**DEPARTMENT OF TRANSPORTATION
STATE OF GEORGIA**

FILE P. I. No. 0005320, Dooly County
NHS00-0005-00(320)
I-75 @ SR 215 Interchange Reconstruction

SUBJECT APPROVED PROJECT CONCEPT REPORT

SUBJECT: PROJECT CONCEPT REPORT

ATTACHMENT 3C
 CONCEPT LAYOUT
 ALTERNATE 3 (PREFERRED)
 NHS-0005-00(320)
 I-75 INTERCHANGE AT SR 215
 PI NO 0005320
 DOOLY COUNTY
 FEBRUARY 06, 2007

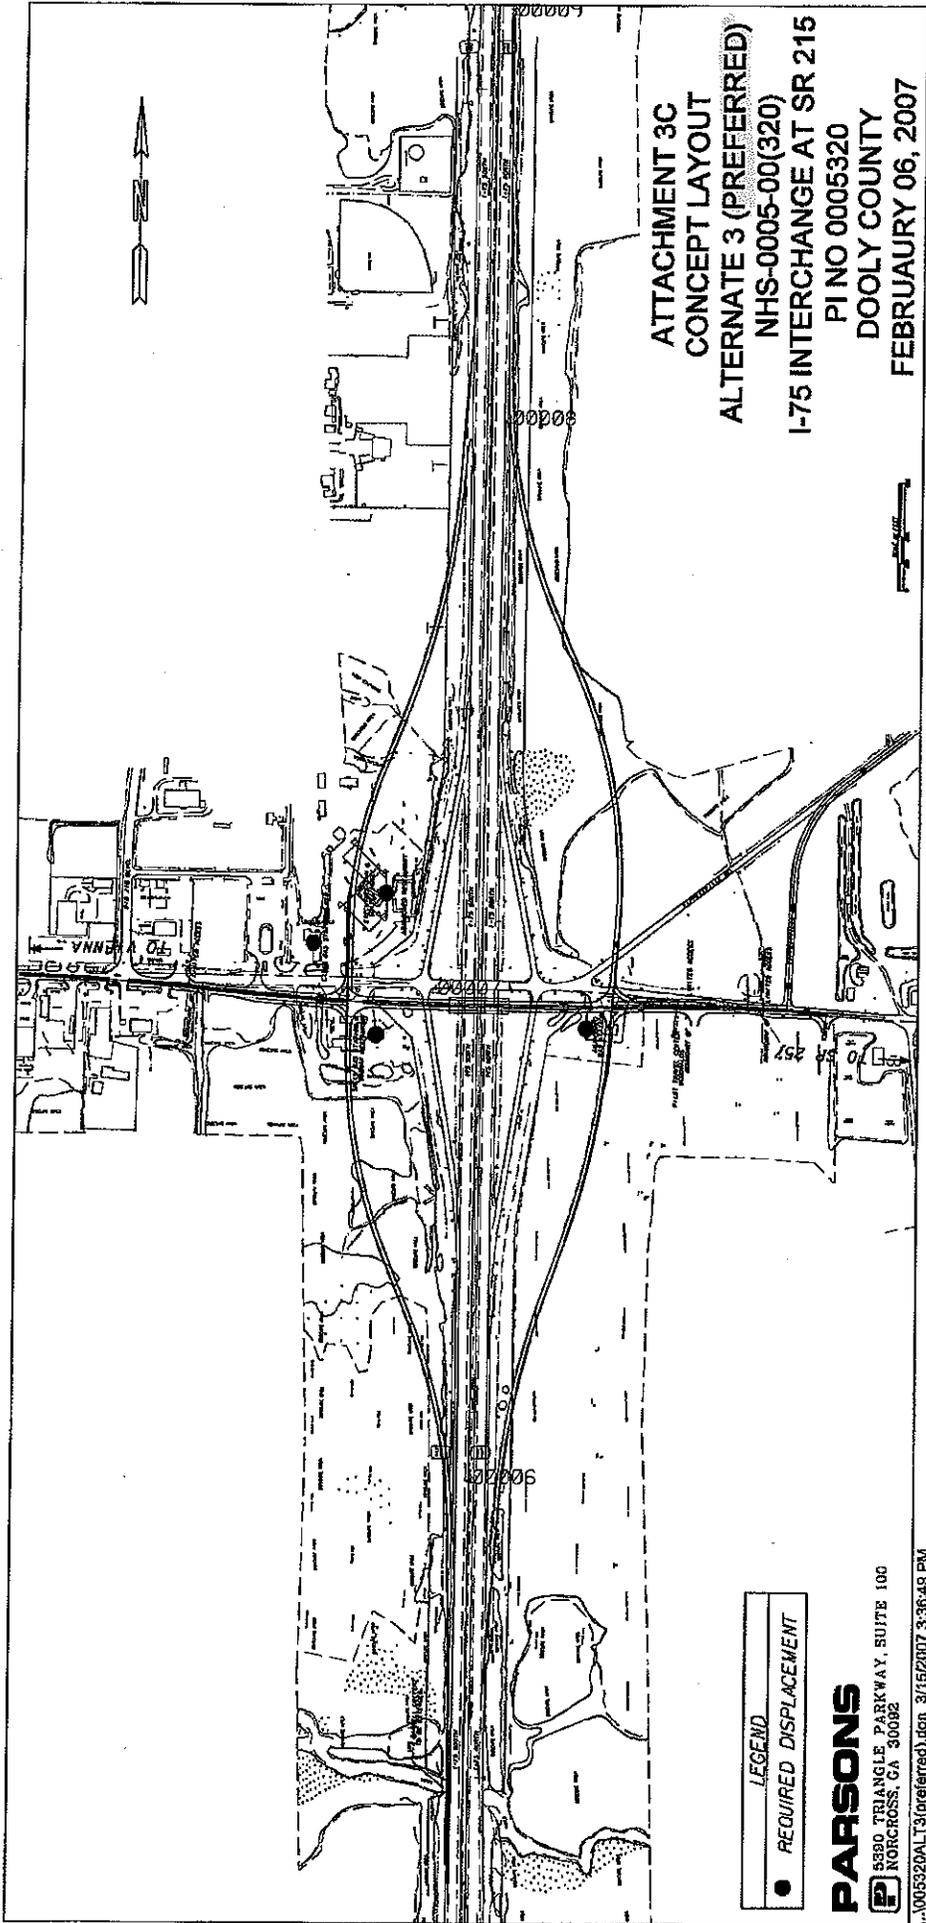
Brink Stokes, District 3 Area Engineer, commented that he favors the preferred alternate due to constructability. Mr. Stokes inquired what kind of grade change there will be at

the ramp heads and how that will affect maintenance of traffic during construction. Mr. Hunley replied that Parsons has not yet evaluated the alternative to that level of detail.
